# Recall Bulletin

**SUBJECT: Compressed Natural Gas (CNG) High Pressure Regulator**

**MODELS: 2011-2014 Chevrolet Express and GMC Savana  
Dedicated CNG Vans (RPO LC8&FHZ&UFP&UFM)**

The Part Information section has been revised to include a new regulator kit part number. Step 1 of the Service Procedure section has been revised. A copy of the customer notification letter has been added. Please discard all copies of bulletin 14321.

**CNG High Pressure Regulator Kit**

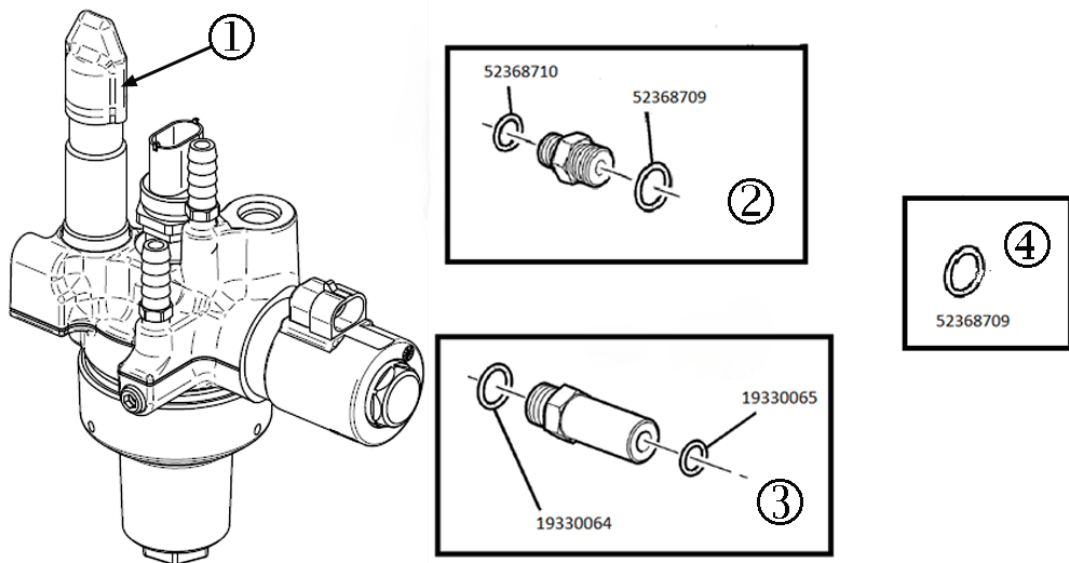
**Note:** The CNG high pressure regulator kit includes a new regulator, O-ring (4) and two fittings (2) (3) with two O-rings each. Remove and discard the regulator and fittings on the vehicle. The regulator, O-ring and two fittings included in the kit **MUST** be used to complete the repair in this field action bulletin. The high pressure regulator comes equipped with a vent cap (1) on the pressure relief tube. This cap (1) prevents contaminants from entering the regulator and should **NOT** be removed.
